STATE OF CALIFORNIA
DEPARTMENT of TRANSPORTATION

**OFFICE OF RIGID PAVEMENTS
and STRUCTURAL CONCRETE**

**Route 08
PM 16.9/R35.1**

**SLAB REPLACEMENT AND
DOWEL BAR RETROFIT**

Figure 8. Saw cut slots

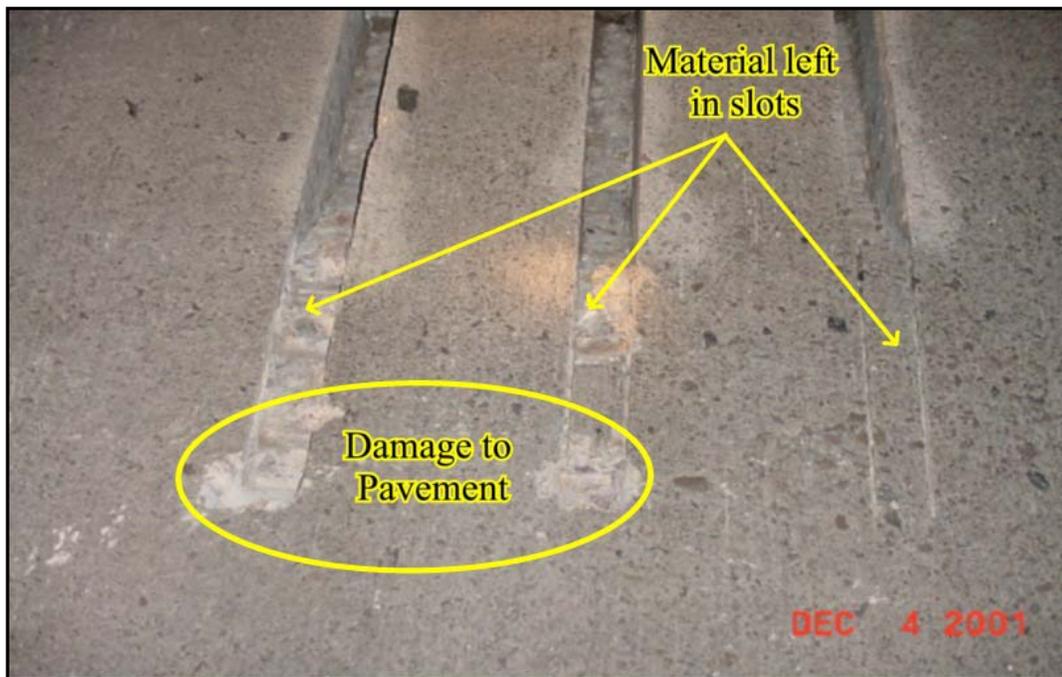
Concrete material left in the pre-cut slots was causing damage to the existing pavement (Figure 8). According to the project special provisions (SP), “ slots shall not be cut more than four hours prior to concrete slot removal. After initial slot cutting, no traffic shall be allowed over these cuts.”

Figure 10. Slot Cleaning

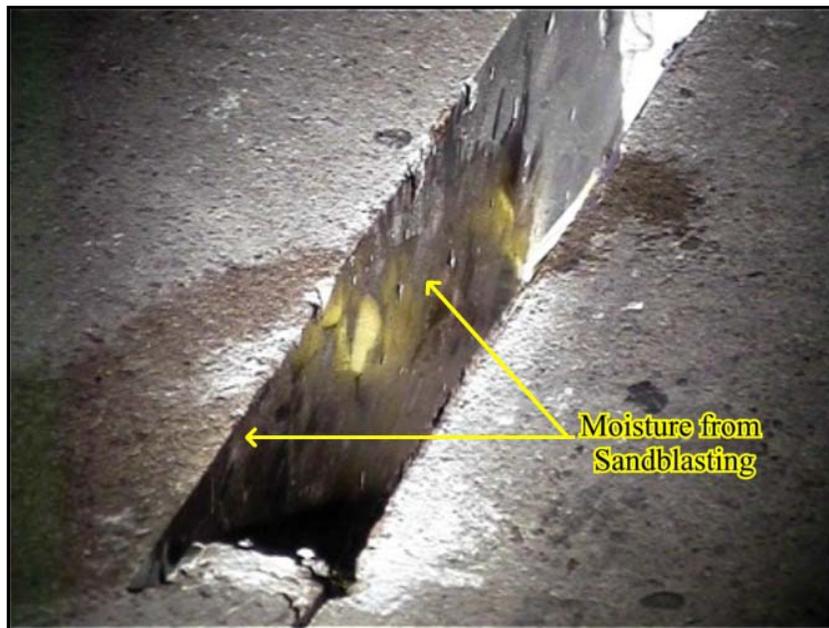
After removing the concrete, the slots were vacuumed and sandblasted to ensure any debris remaining is removed and all surfaces are clean and dry. An inspection of one of the slots revealed that moisture remained after being sandblasted (Figure 10).

From the project SP; “Immediately after vacuuming all debris from the slot, the slots shall be final cleaned with **moisture-free**, oil-free compressed air having a minimum pressure of 620 KPa.”

Figure 11. Caulking Filler

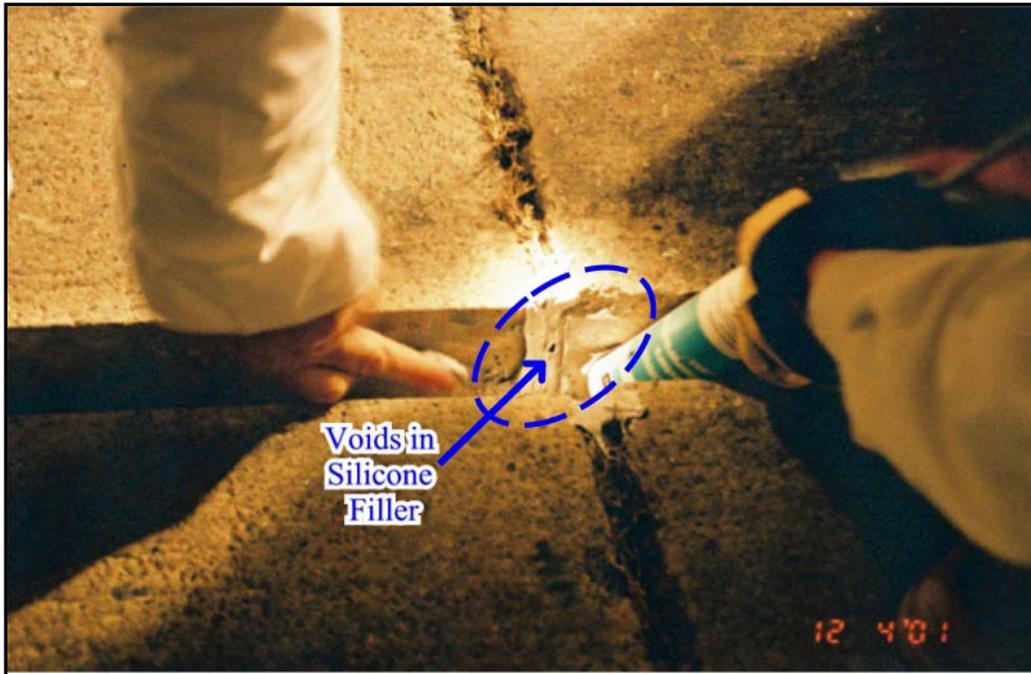
In preparing the slots for dowel bar placement, the construction crew used a silicone filler to seal the existing transverse joint within the slot. In one of the slots, voids were noticed in the filler (Figure 11).

According to the project SP; “The Contractor shall seal the existing transverse joint at the bottom and the sides of the slot with caulking filler. This caulking filler shall be placed to a minimum of 13 mm beyond the edges of the slot in the existing transverse joint. Any other cracks within the slot shall also be filled with caulking filler.

Figure 12. Dowel Clearance

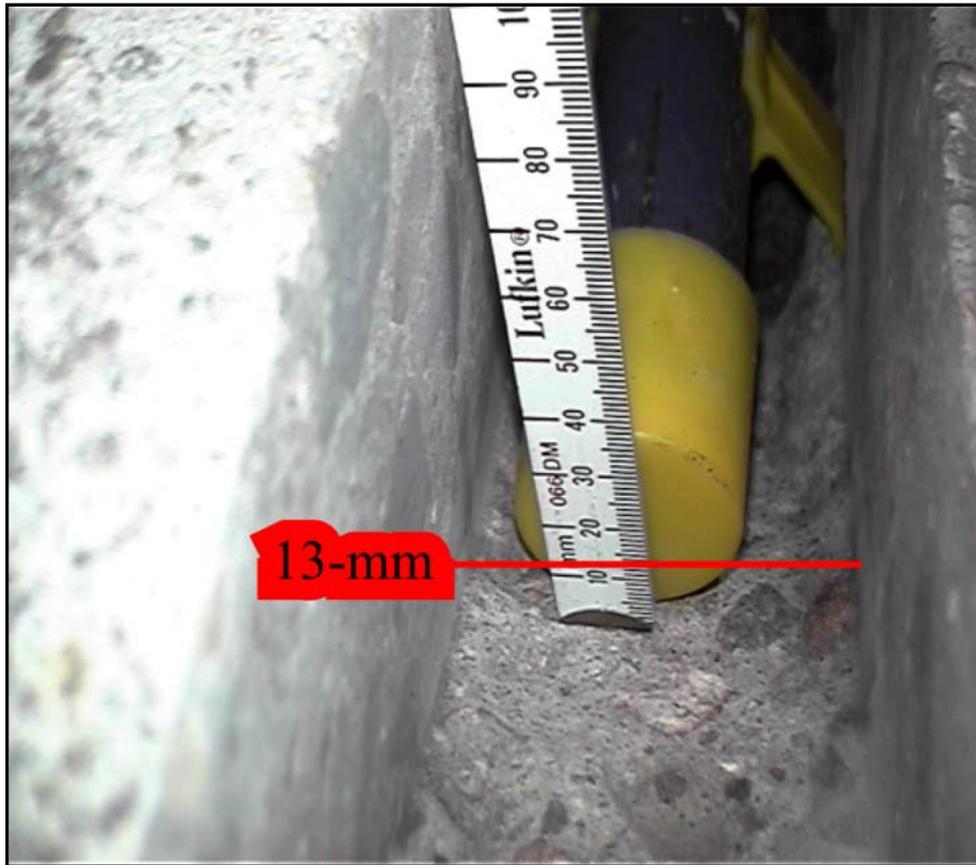
The placement of the dowel bars in the slots revealed more discrepancies. The most obvious was the lack of clearance between the bottom of the dowel bar end and the bottom of the slot.

Some of the slots did not meet the 13-mm clearance required by the project plans and specifications. In one of the dowel bar placements inspected, there was no clearance between the dowel bar end and the slot bottom (Figure 12).

From the project SP; “The (dowel bar) chair shall provide a minimum of 13-mm clearance between the bottom of the dowel bar and the bottom of the slot. The dowel bars shall be placed to the depth shown on the plans, parallel to the traffic lane centerline and the top of the roadway surface, and at the middle of the slot, all within a tolerance of 6 mm. Dowels shall be centered at the transverse joint, such that not less than 205 and not more than 255 mm of the dowel extend into each adjacent panel.”

Figure 13. Fractures from using heavy Jackhammers

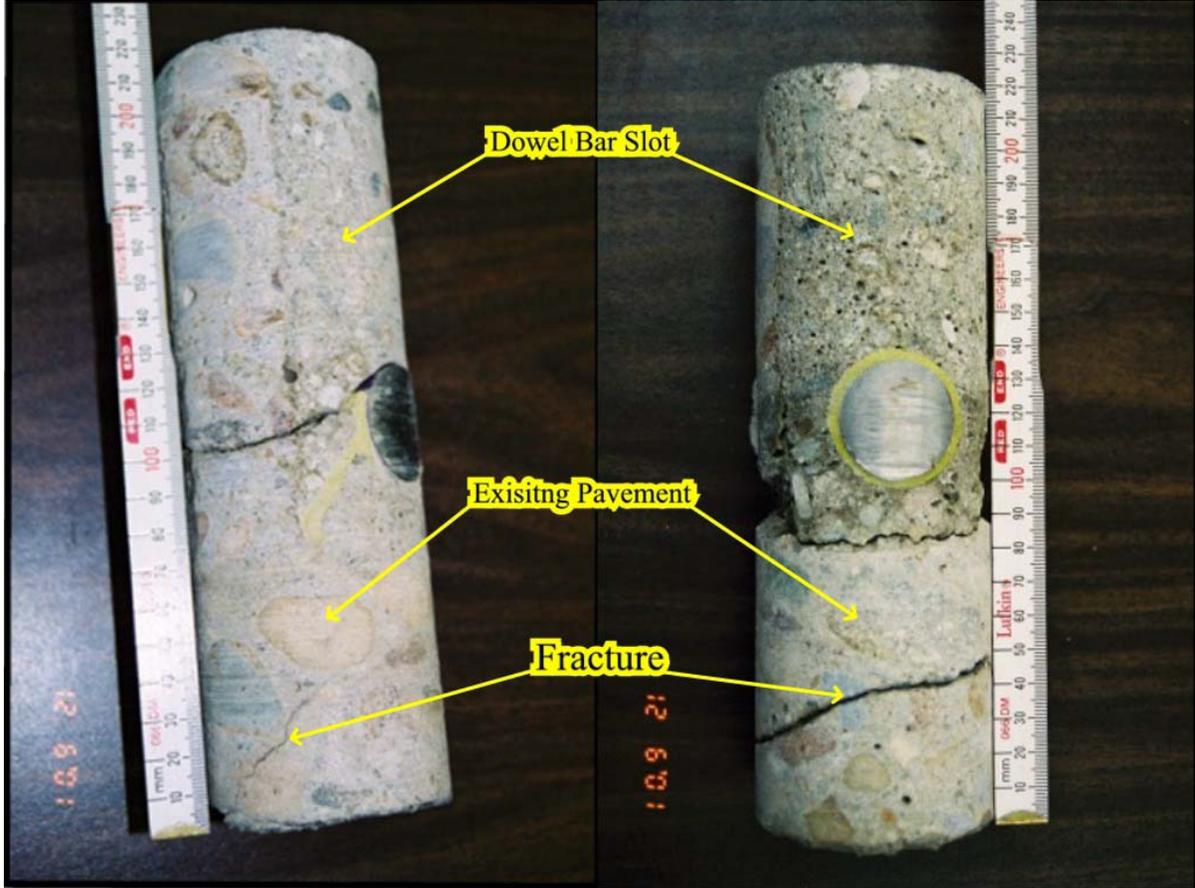
In a meeting with the Resident Engineer on December 6, 2001, core samples from the retrofit installations were examined. A couple cores showed that the existing pavement below the dowel bar slots had been fractured from the use of the heavier jackhammers (Figure 13).

Figure 14. Consolidation of Grout Material

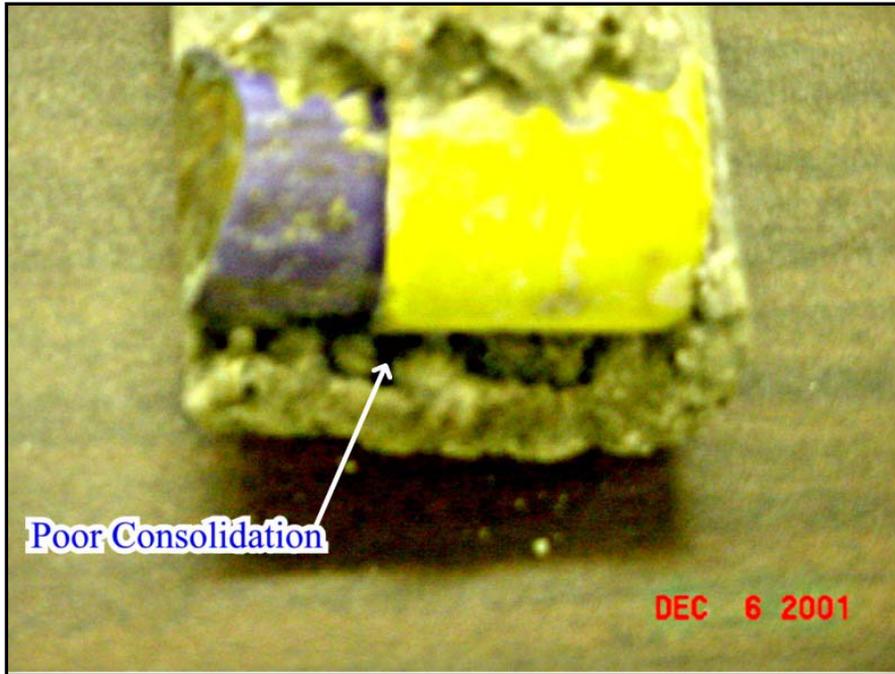
Another core sample showed that fast-setting grout was poorly consolidated around the dowel bar (Figure 14). Numerous voids were evident.

“The grout shall be vibrated with a small hand held vibrator capable of thoroughly consolidating the grout material into the slot and around the dowel bars. All grout shall be placed while fresh, and before the grout has taken an initial set.
